sixth floor plan _ proposed

THE BARTLETT SCHOOL OF THE BUILT ENVIRONMENT
UCL
22 Gordon Street, London. WC1H 0QB

seventh floor plan _ proposed

roof plan _ proposed

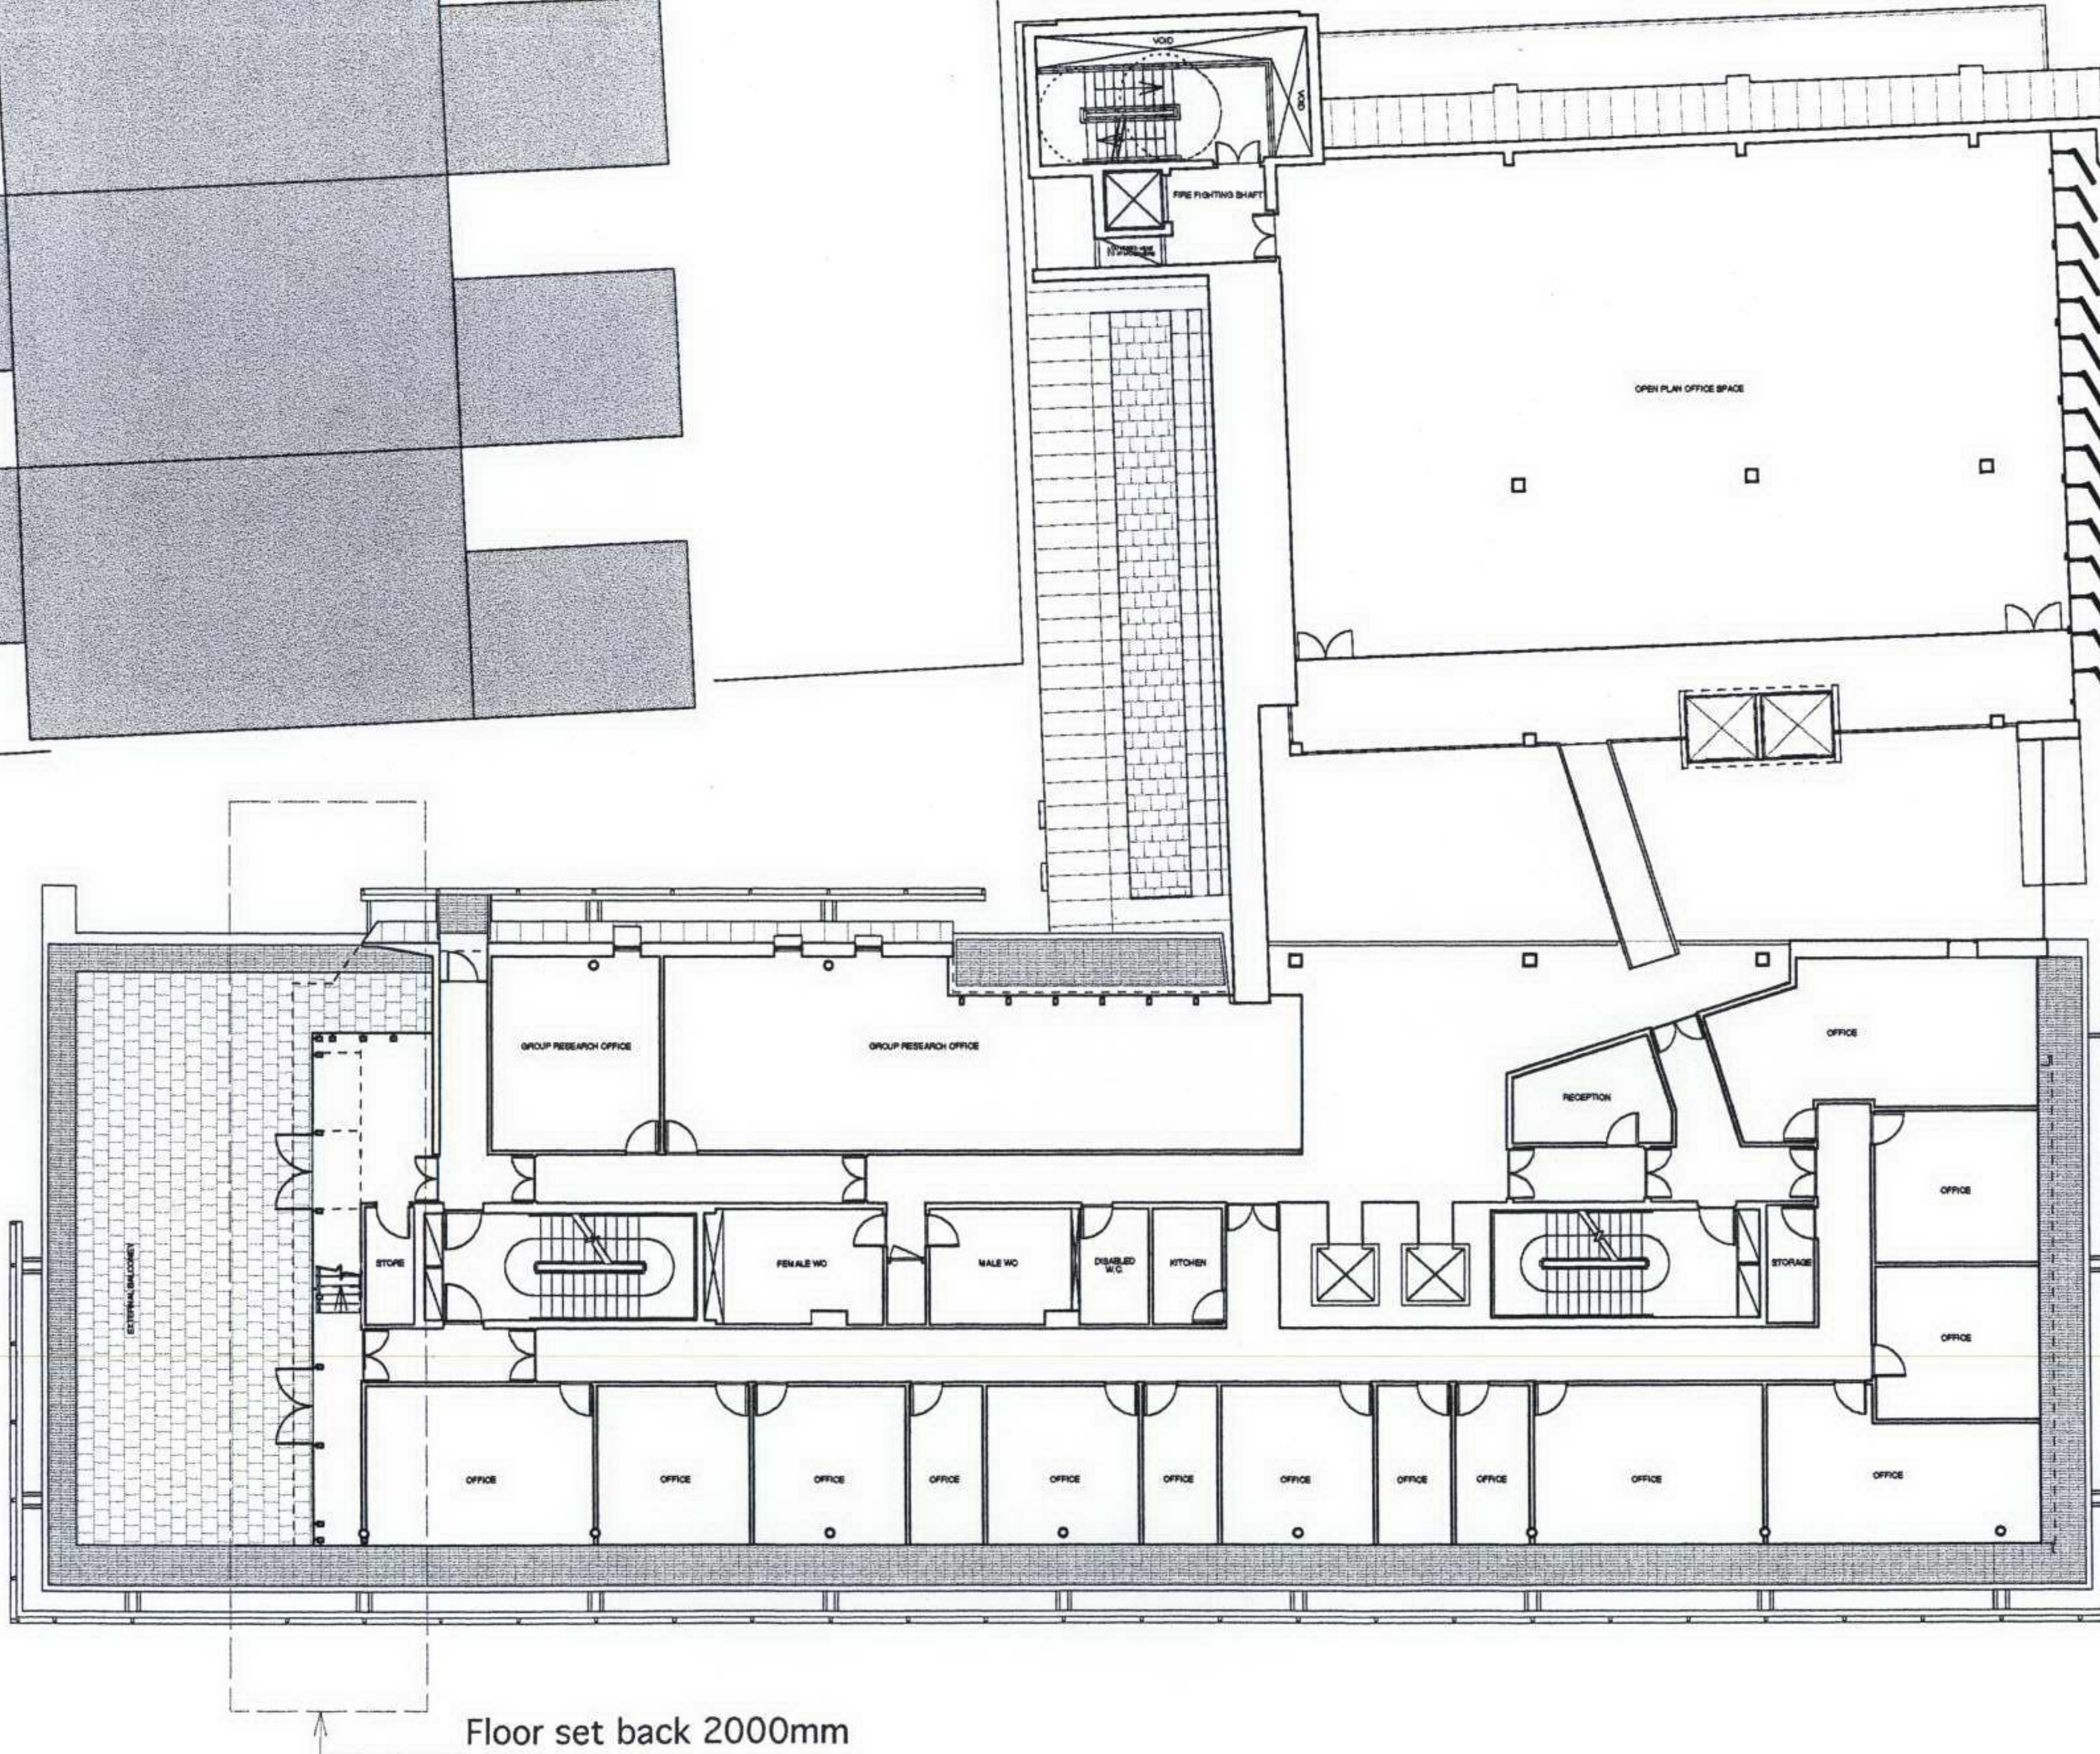
- Eastern edge of glass facade set back 2m. Changes are in response to comments by English Heritage

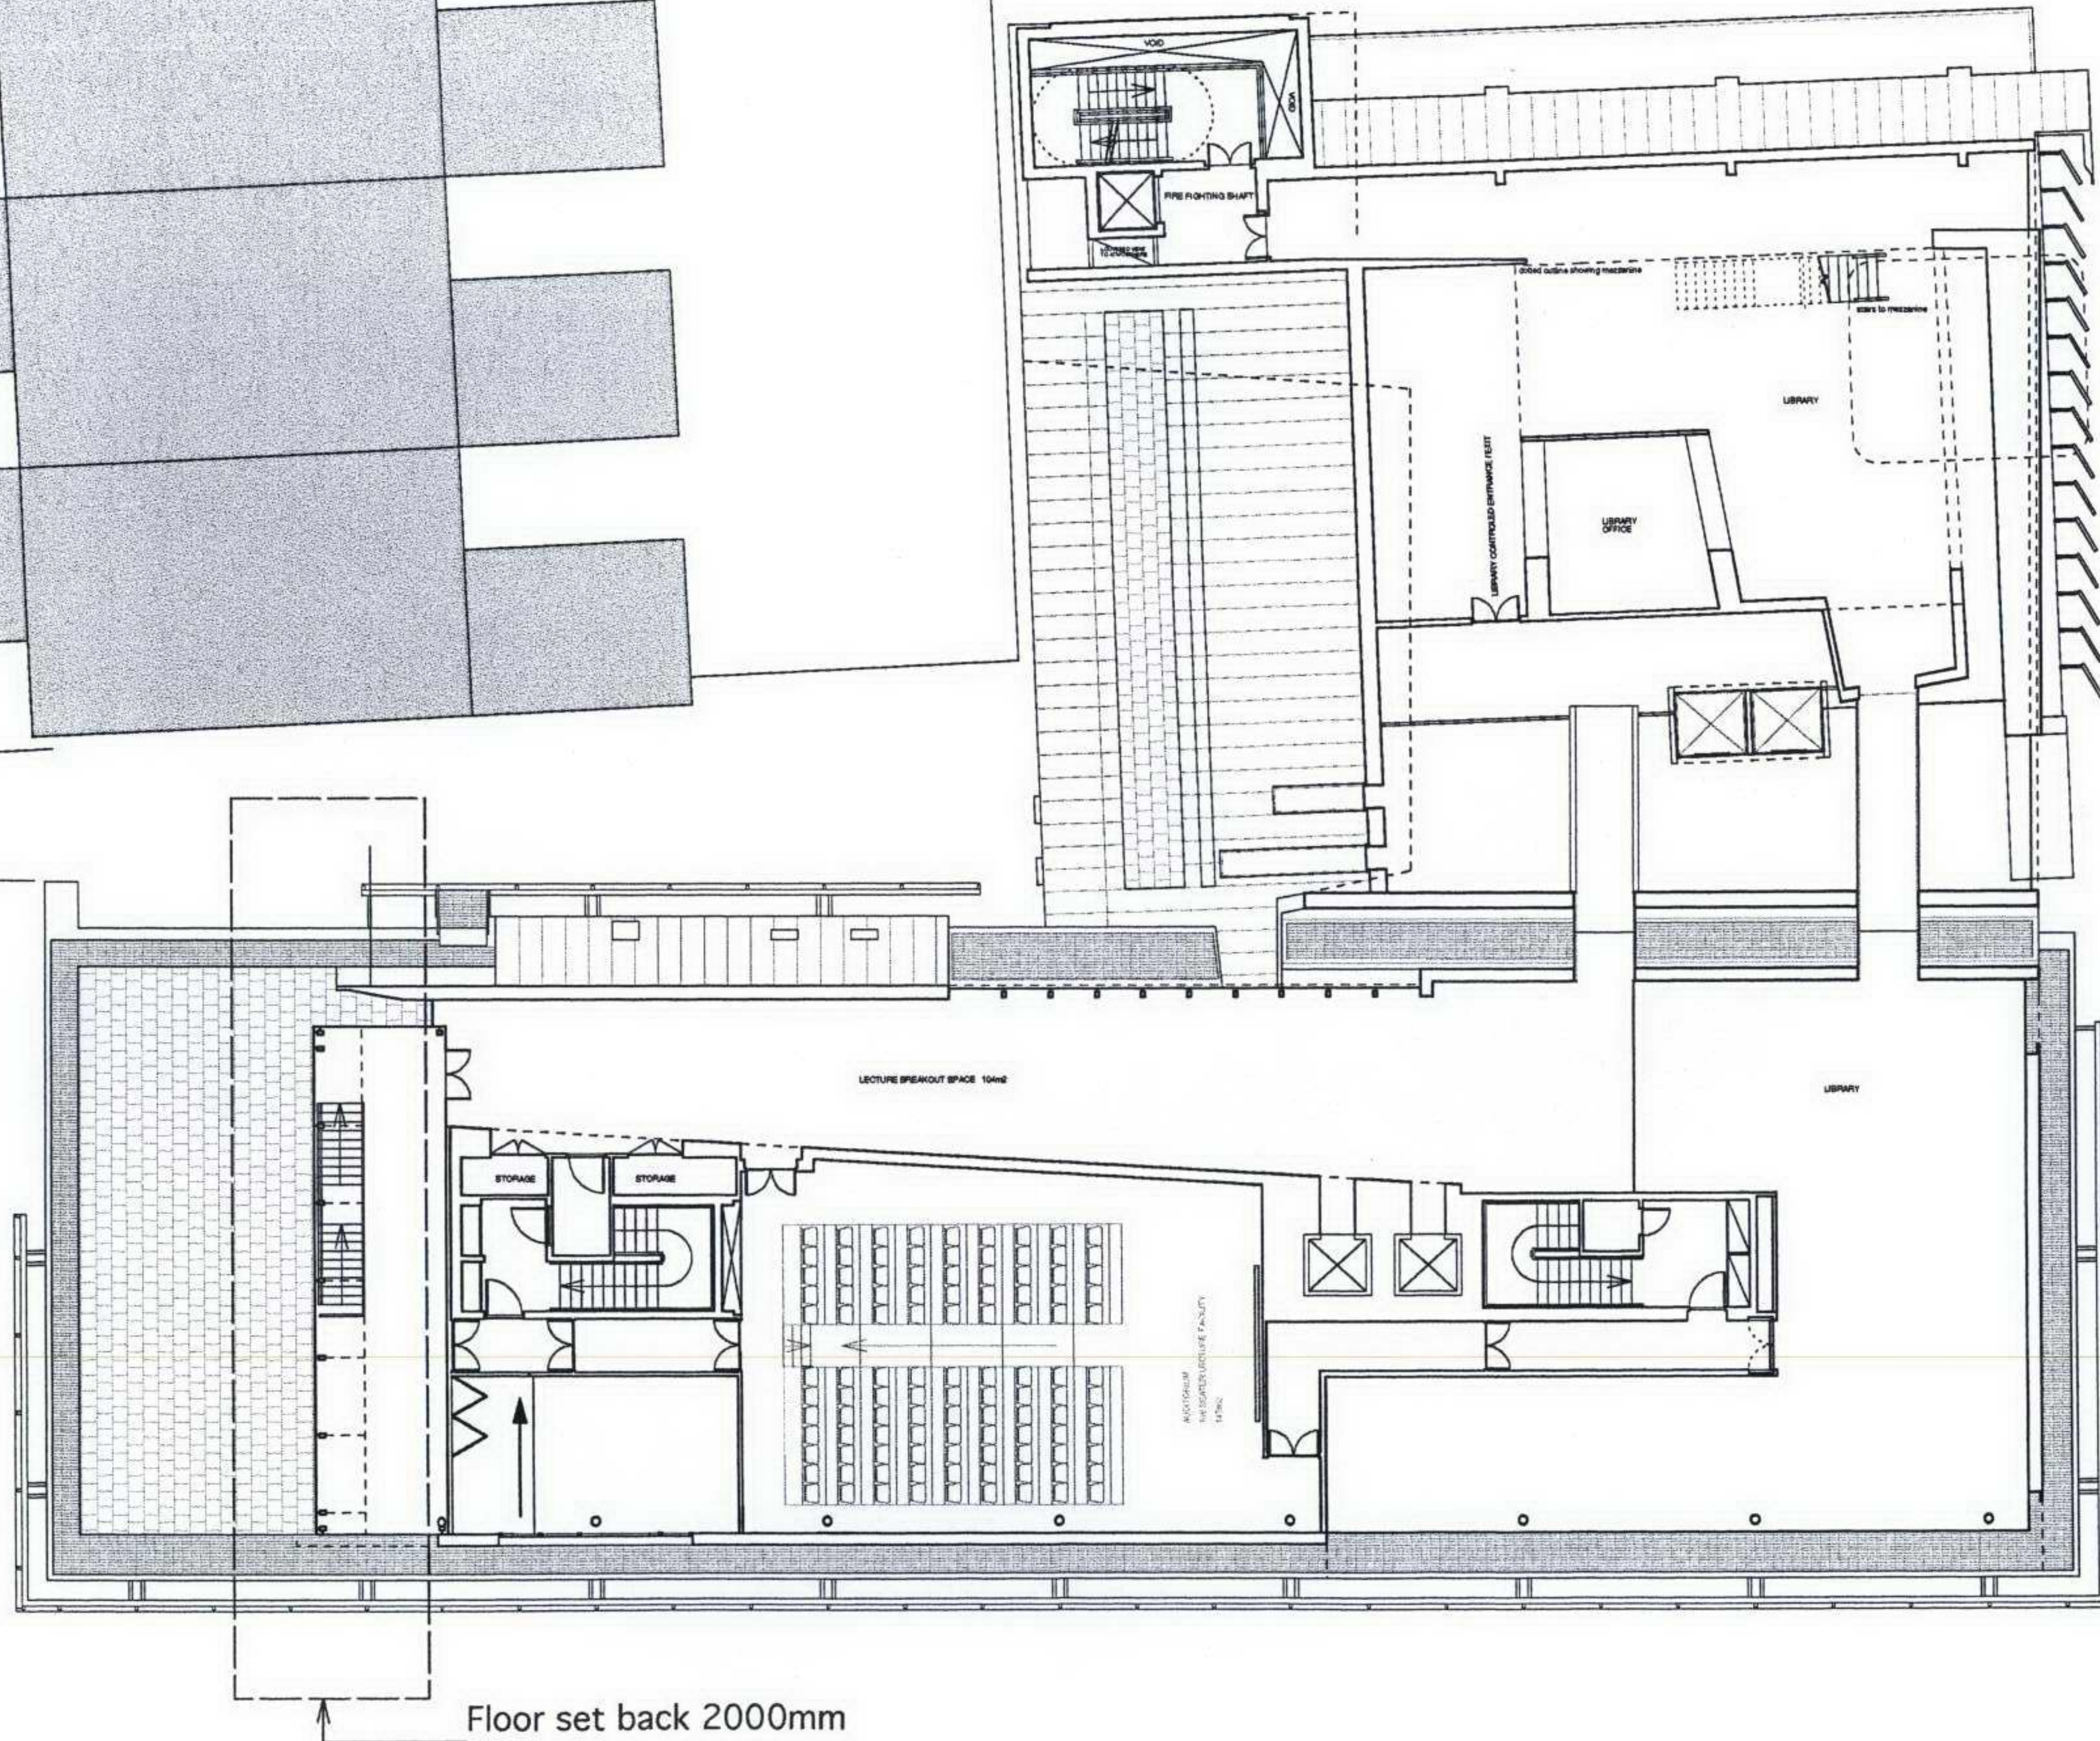
Revision 05, 12.08.06
- Eastern edge of glass facade set back 2m. Changes are in response to comments by English Heritage

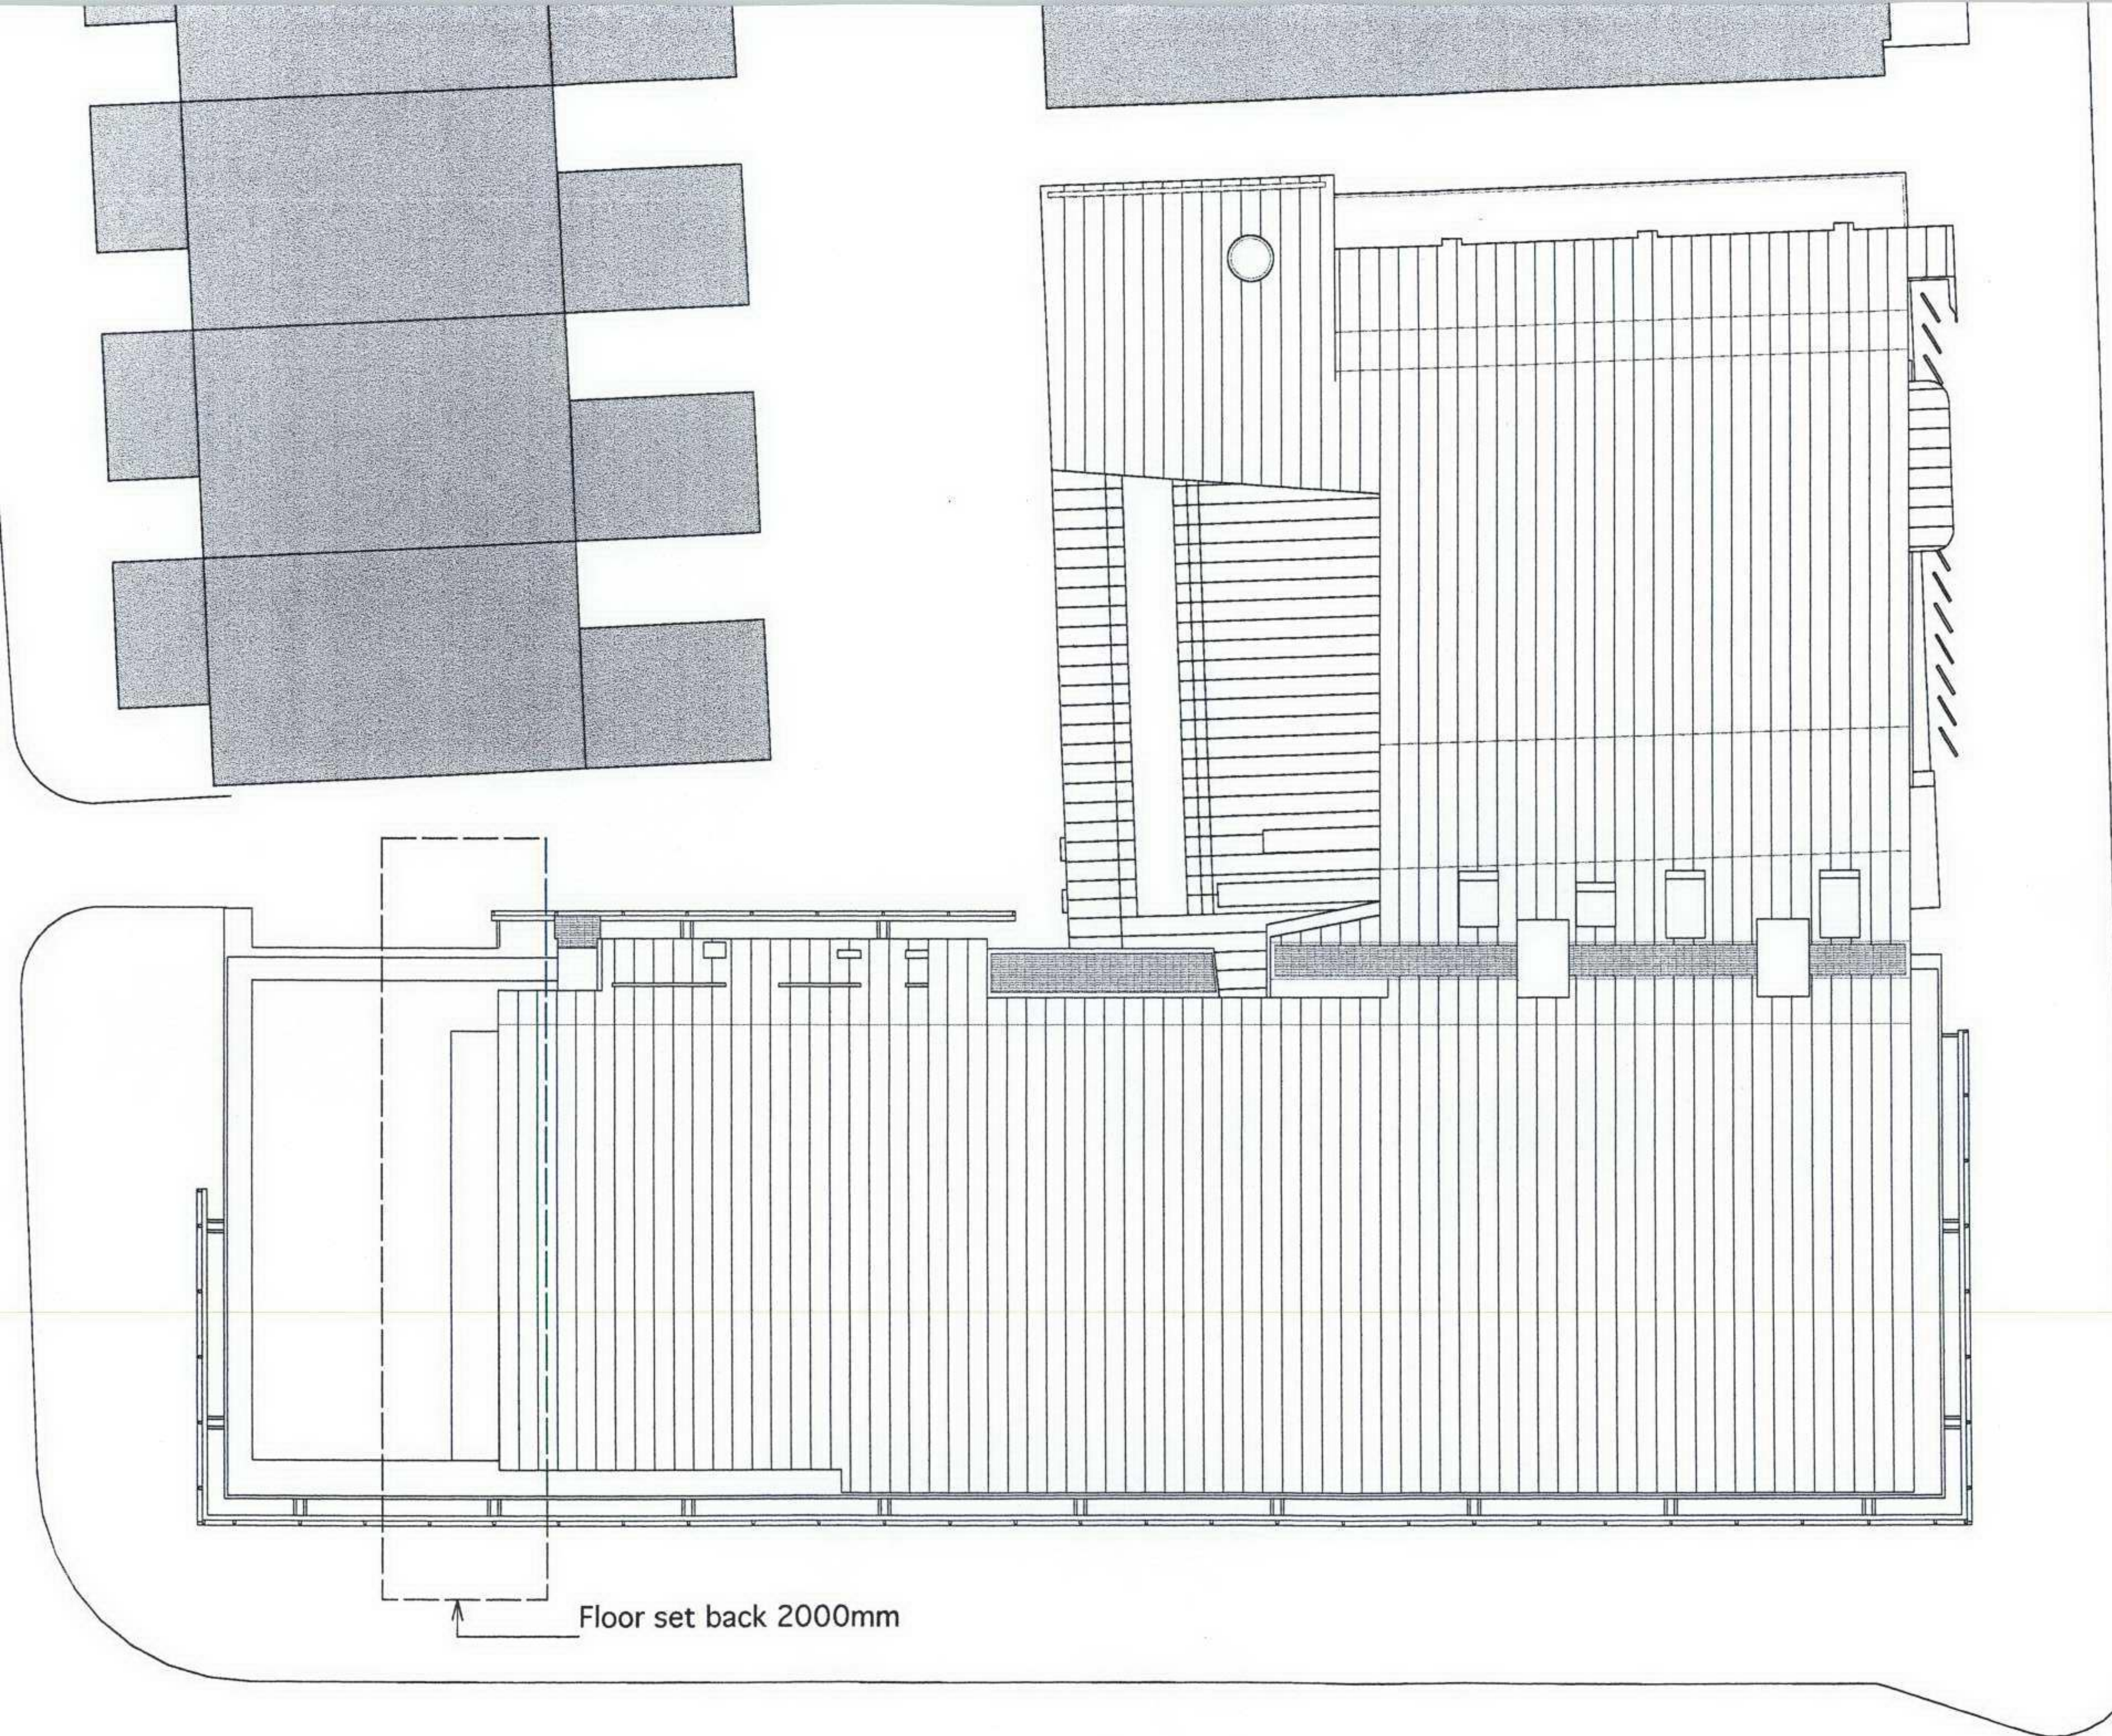
- Eastern edge of glass facade to roof set back 2m. Changes are in response to comments by English Heritage
